SUBJECT: INTERROGATORIES FOR PERMANENT DEWATERING SYSTEM -
MIDLAND PLANT - UNITS 1 AND 2

Midland Plant Units 1 and 2
Hydrologic Engineering Section
Interrogatories
Docket Nos. 50-329/330

CONSUMERS POWER COMPANY'S (APPLICANT'S)
ANSWER TO NRC STAFF INTERROGATORIES DATED 11/26/80

Figure 1

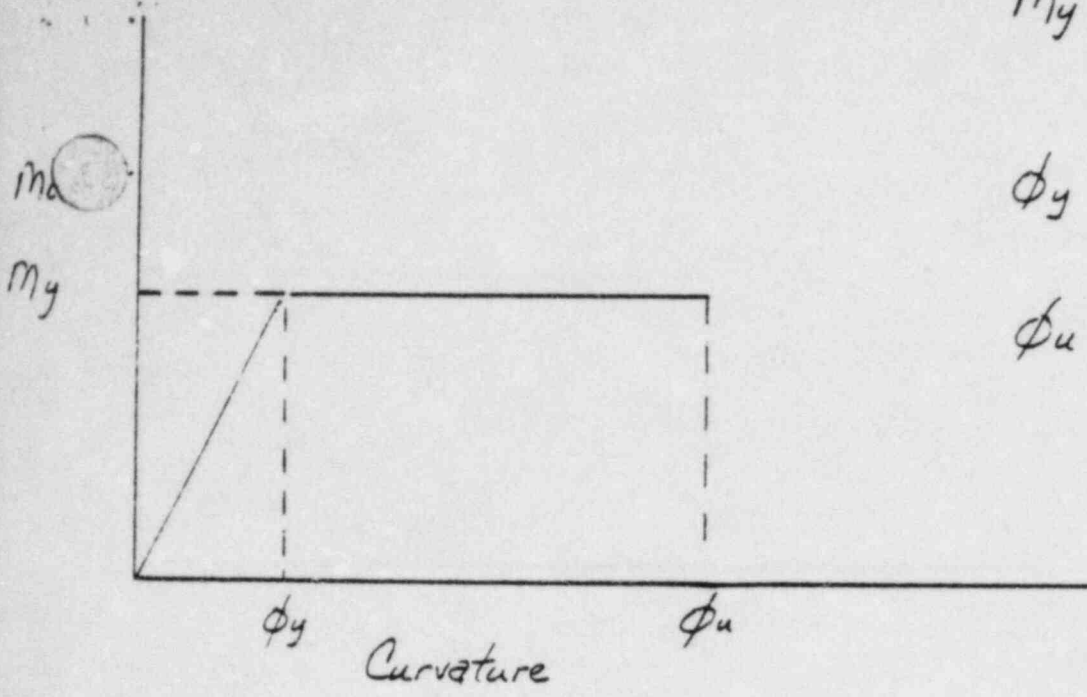
In the response to Question 15 of the NRC request, regarding plant fill, it is stated that, "differential settlement primarily induces additional strain, which is a self-limiting effect and does not affect the ultimate strength of the structural members." Additional clarification of this statement is needed.

When a structural element is subjected to curvature (ϕ), tensile strain is induced in the convex side and compressive strain in the concave side of the element (Figure 1). For a concrete structural element, the theoretical relationship between curvature and moment can be established based on the stress-strain relationship of concrete and reinforcing steel.
